**MASTER DEVELOPMENT DRAINAGE PLAN FOR
LOT 1177 WOODMEN HILLS FILING #10
EL PASO COUNTY, COLORADO**

OCTOBER 2020

TNE Job No. 2015.00
County Job No. SKP-20-003

FIGURE 7
SHEET 2 OF 5

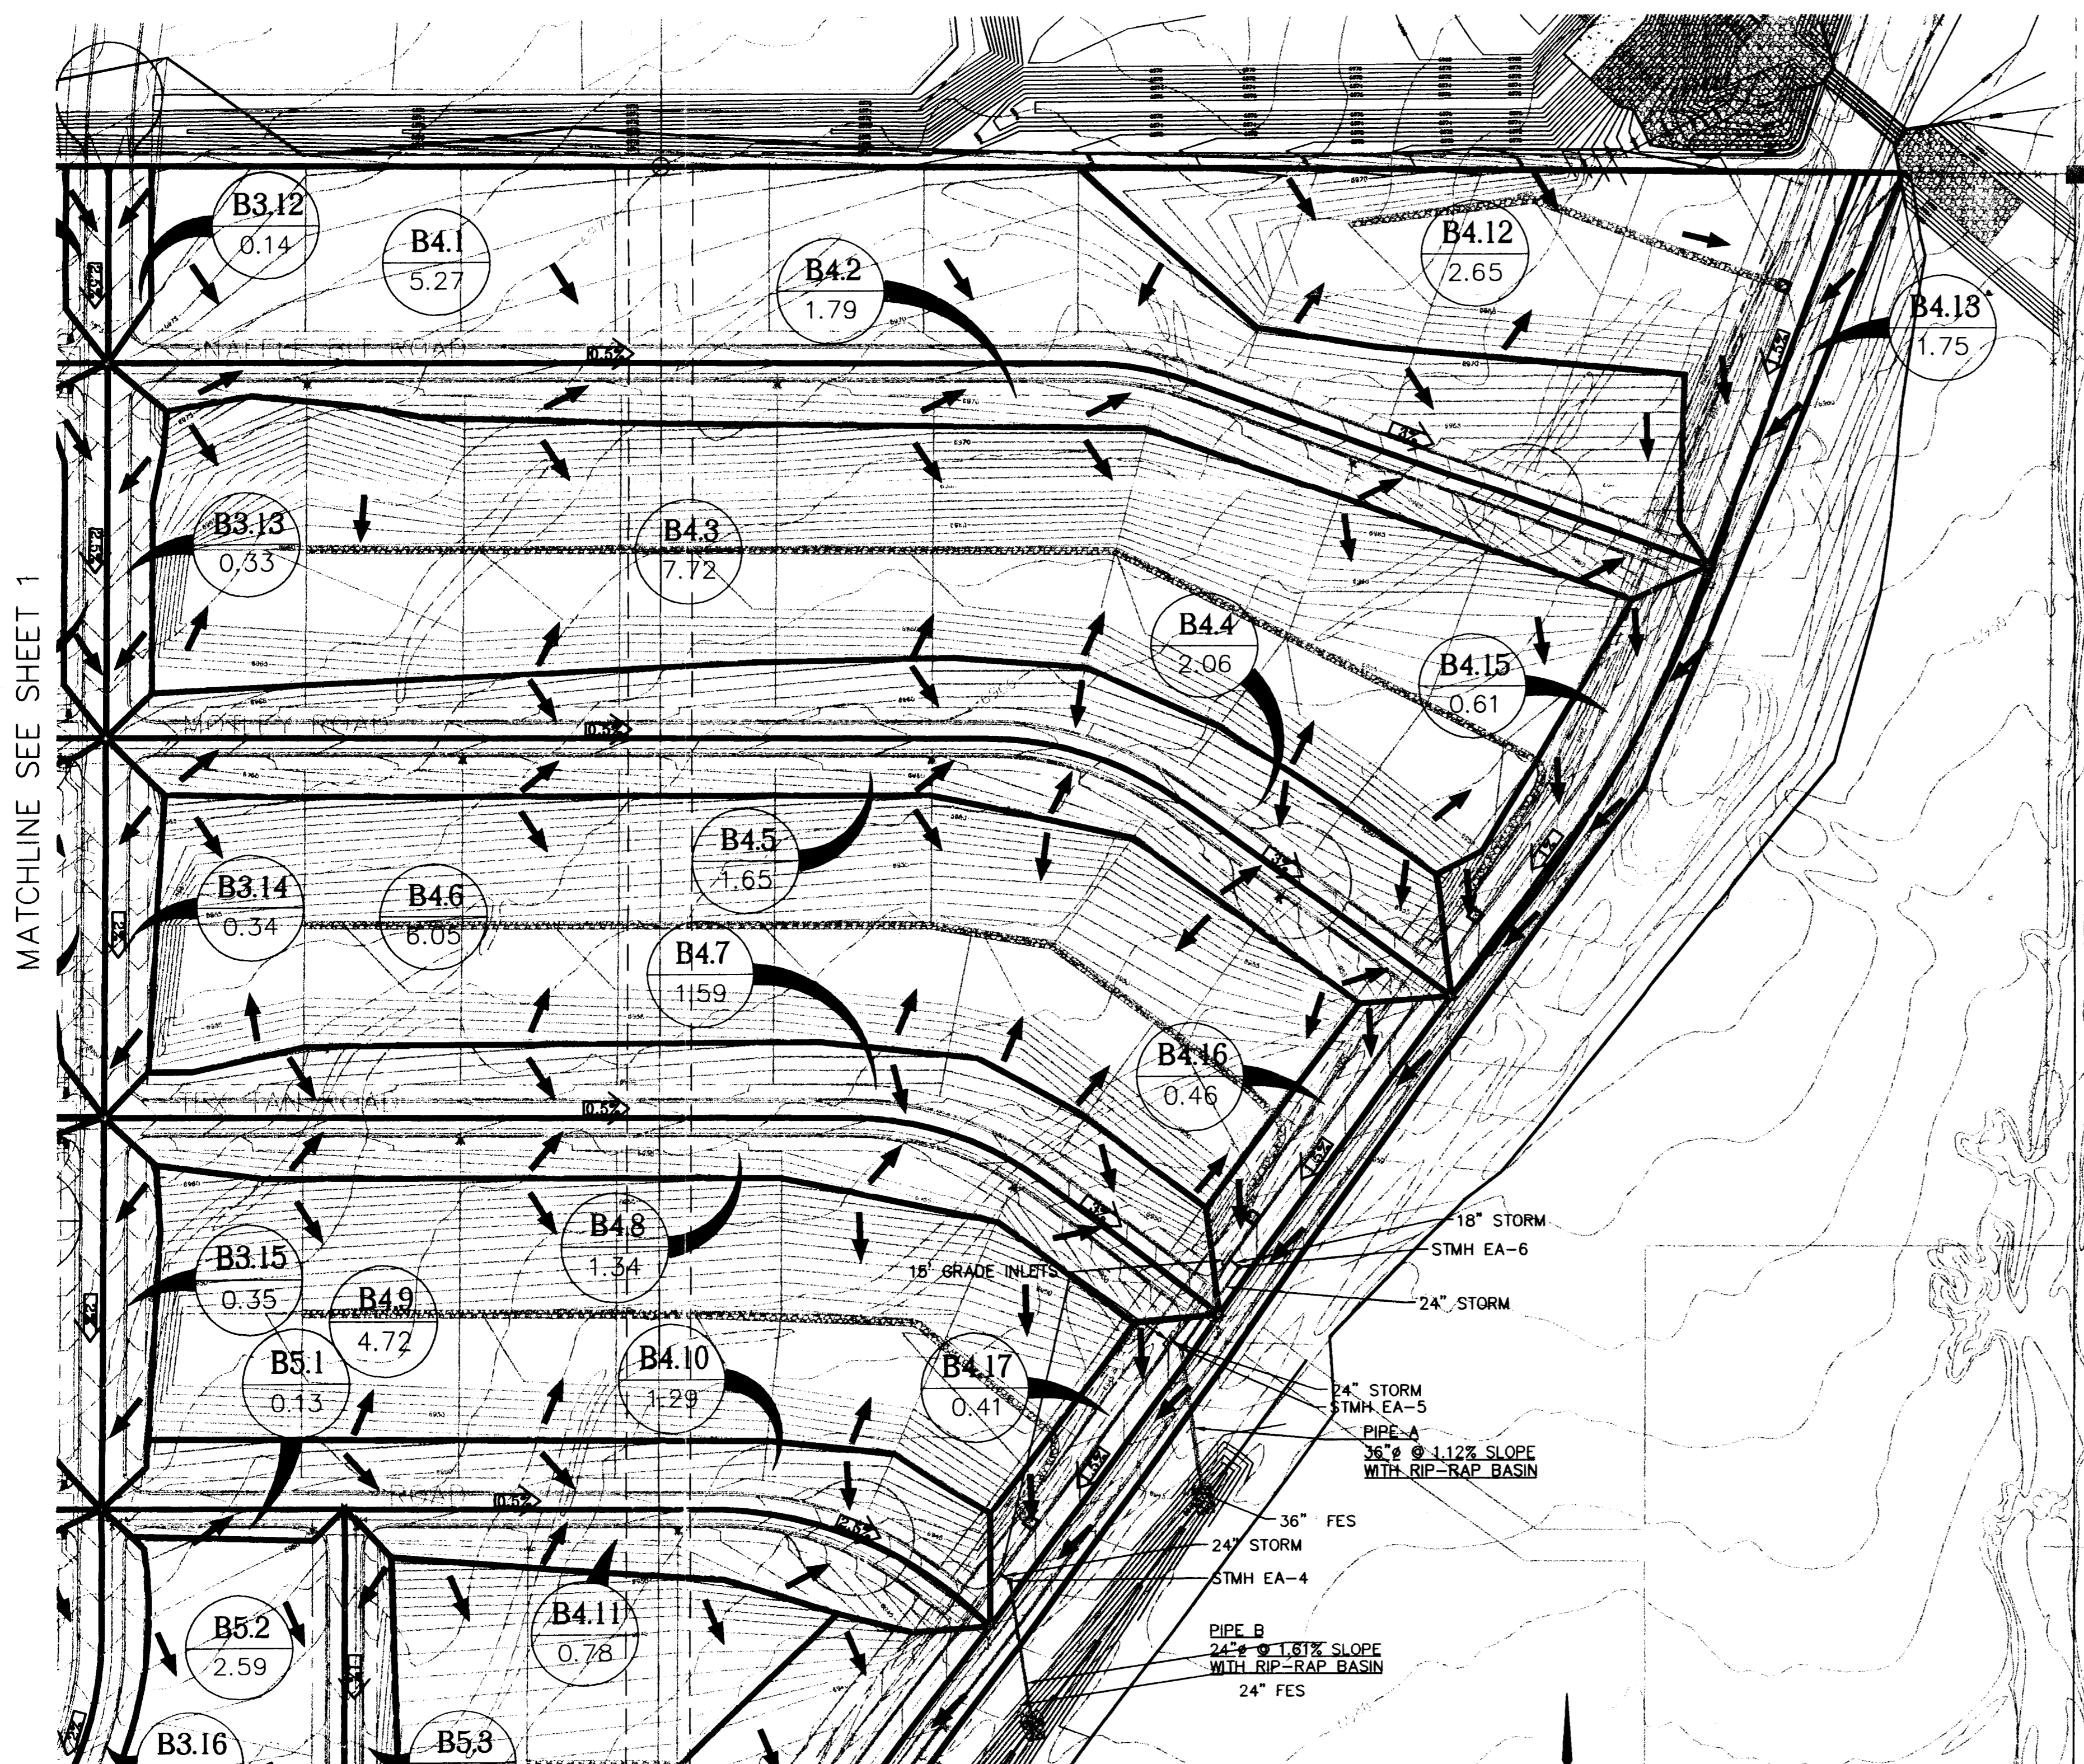
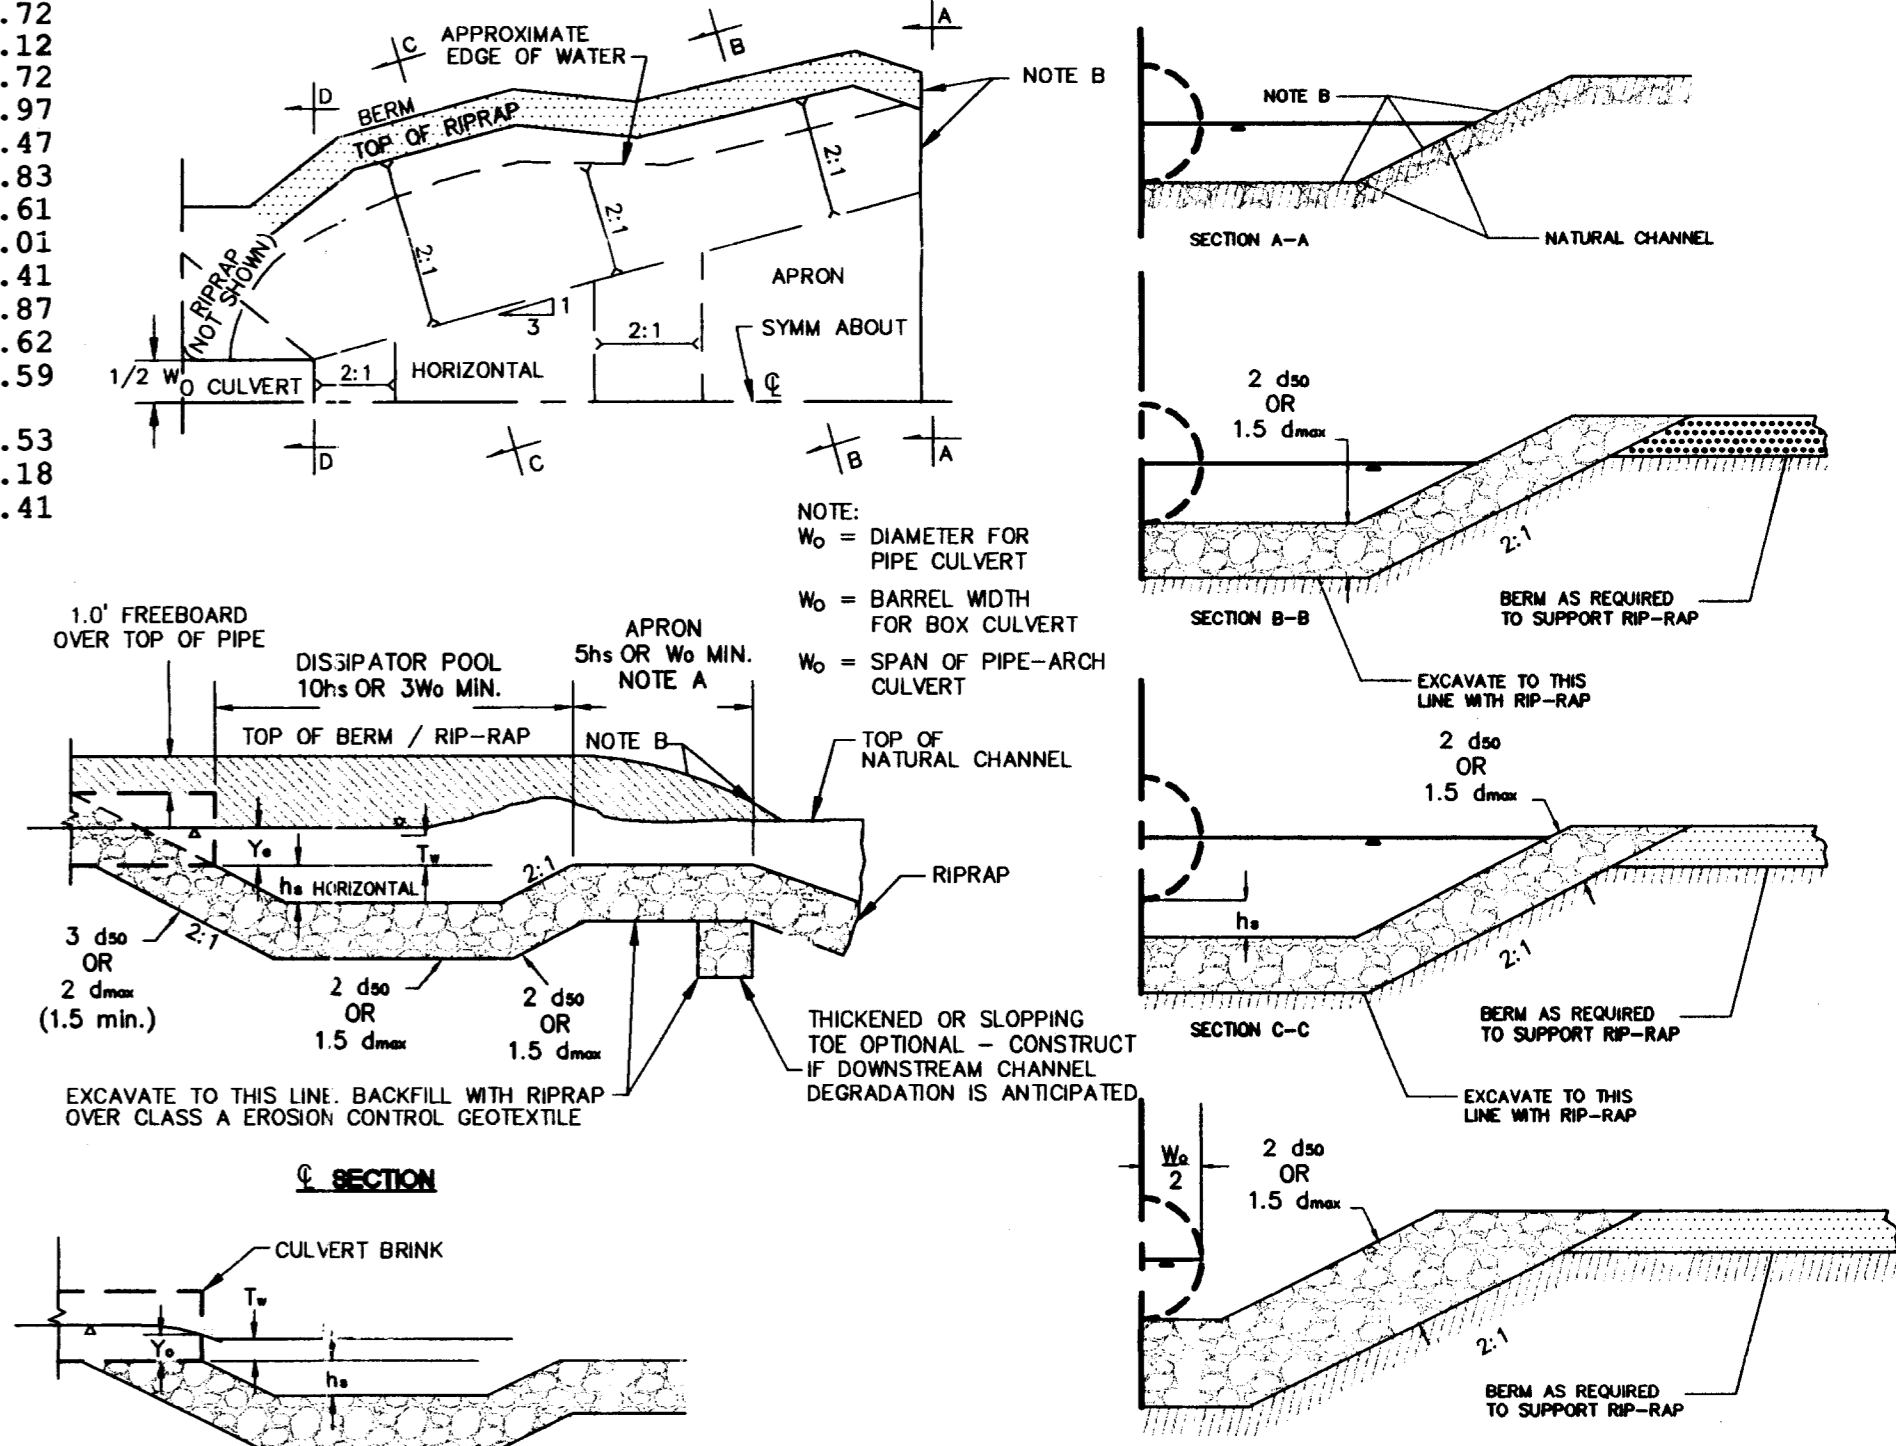
Please provide excerpts of the portions of this report that describes the flow that is conveyed to these 4 storm sewers on this page. Otherwise describe in your narrative these offsite tributary areas/flows that are impacting your site.

PROPOSED DRAINAGE MAP

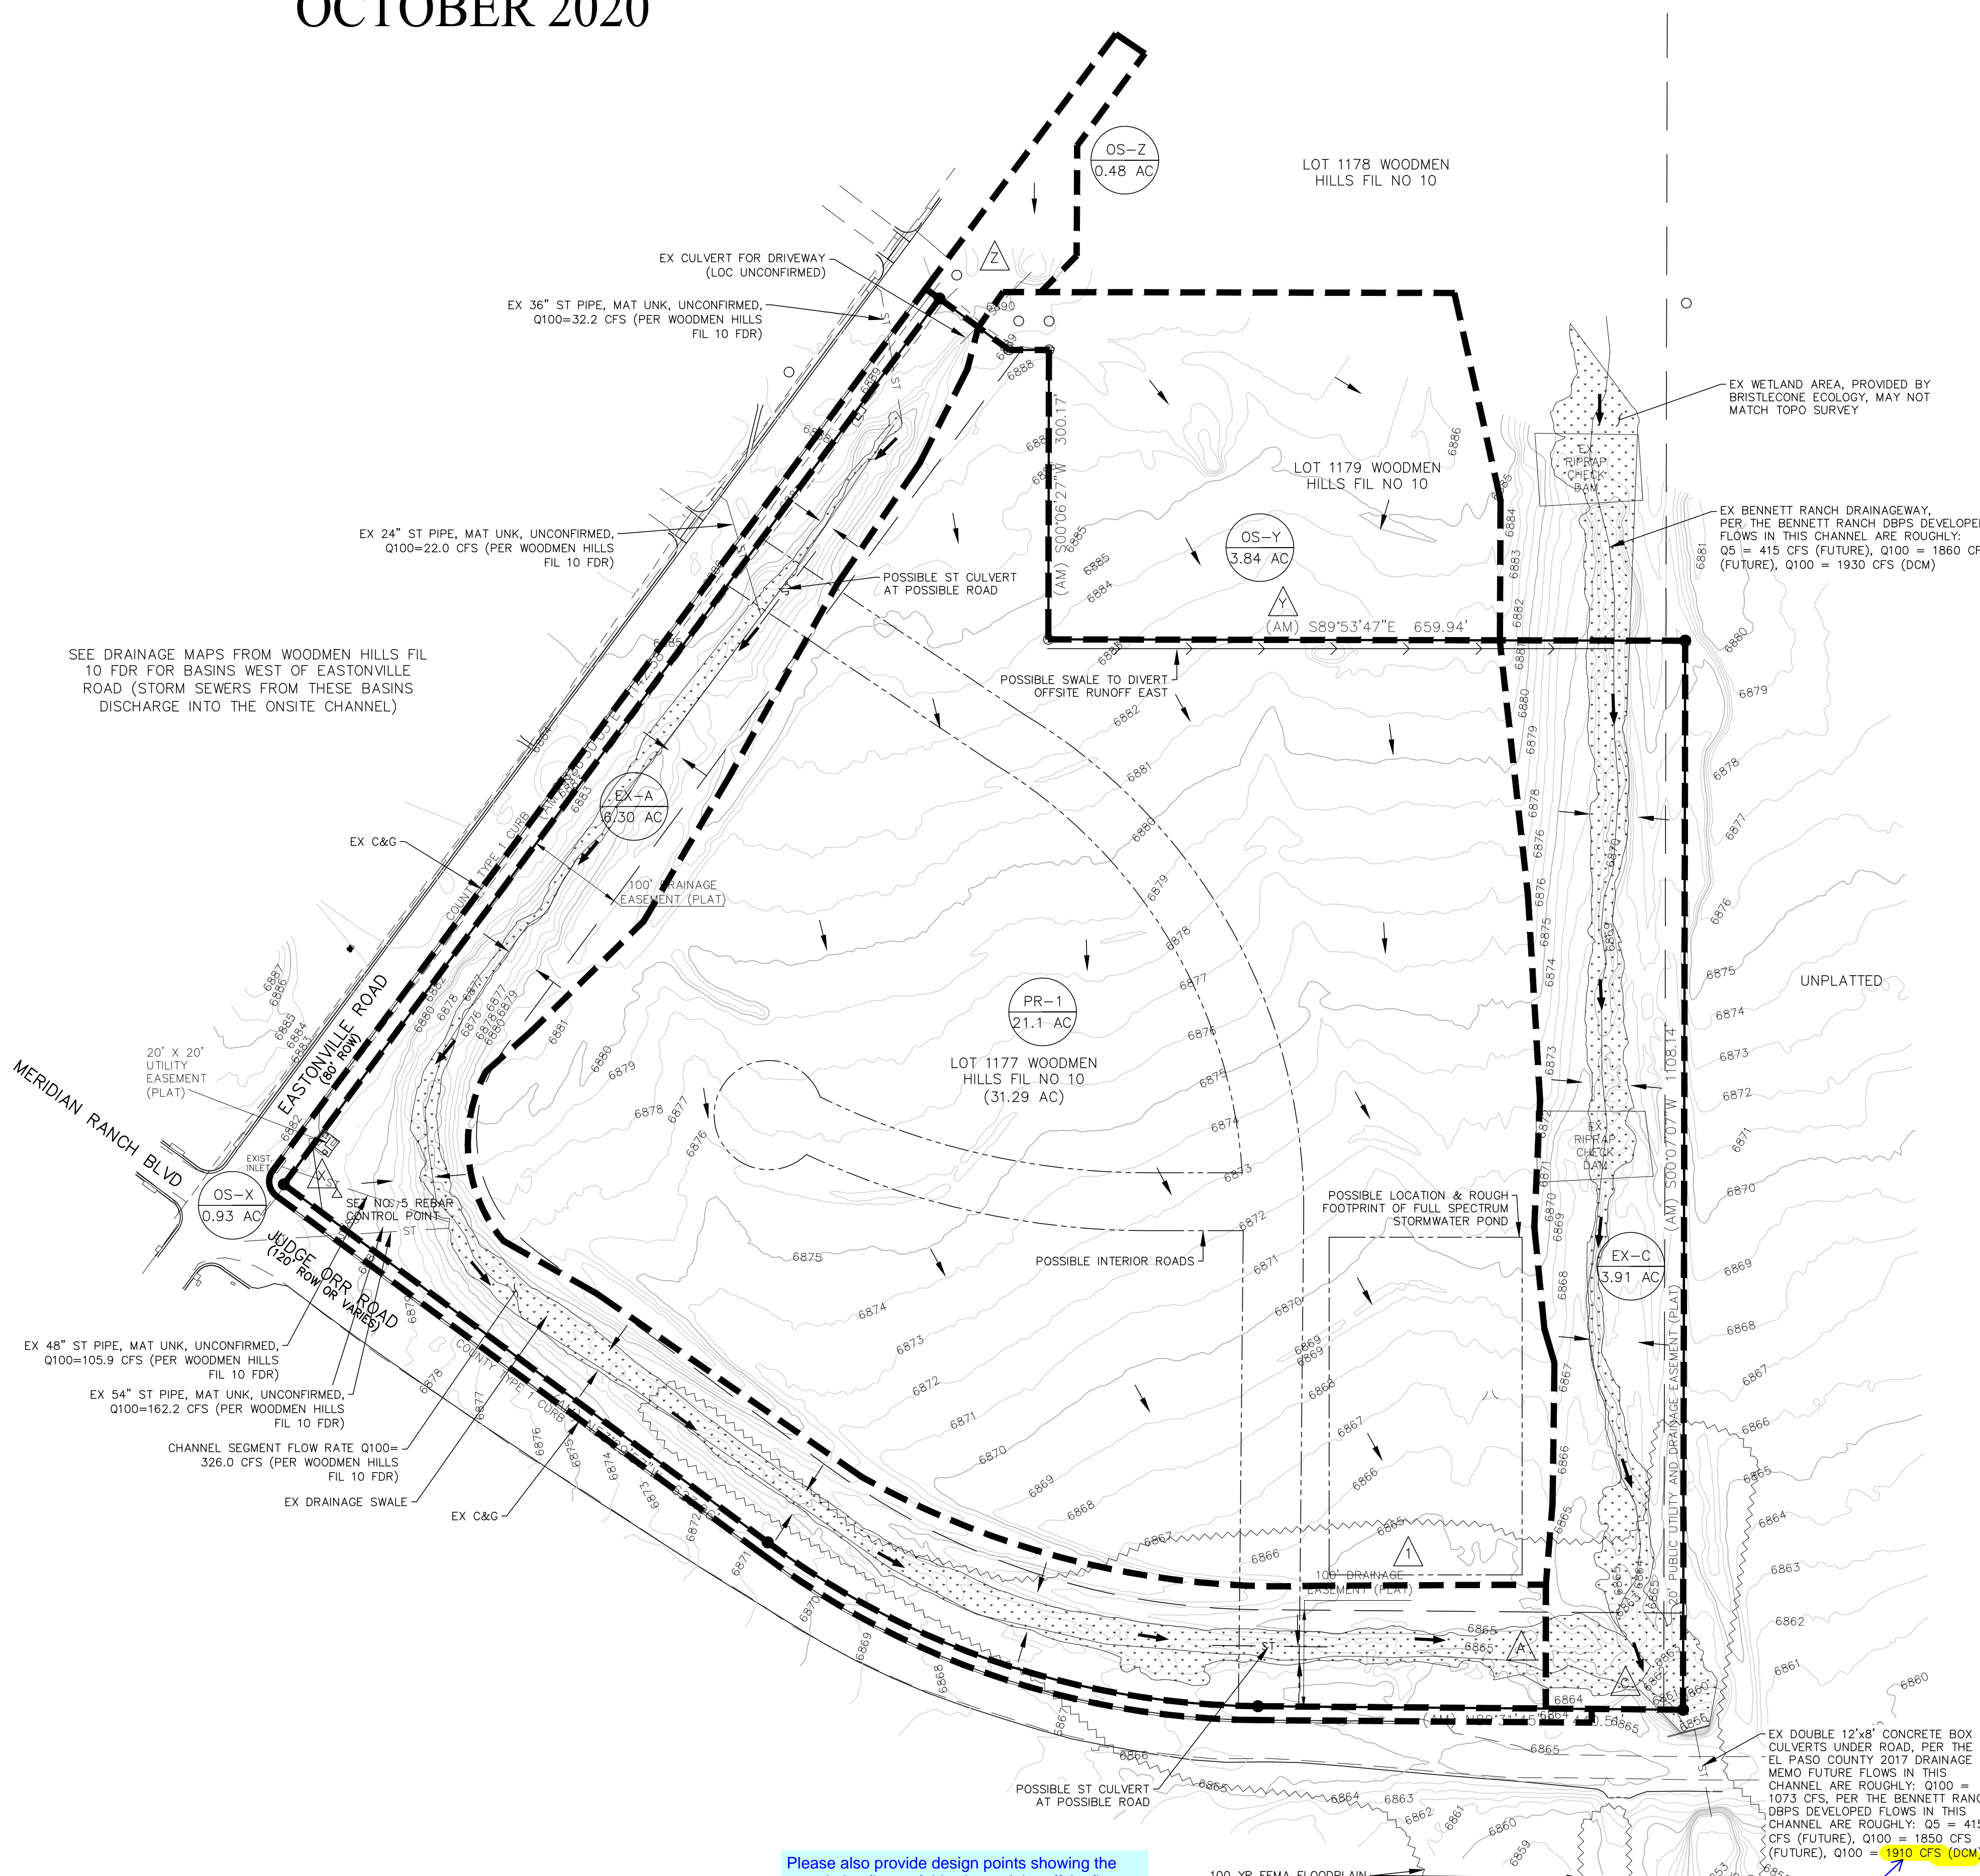
Please also provide design points showing the cumulative flows of this site and the offsite flows.
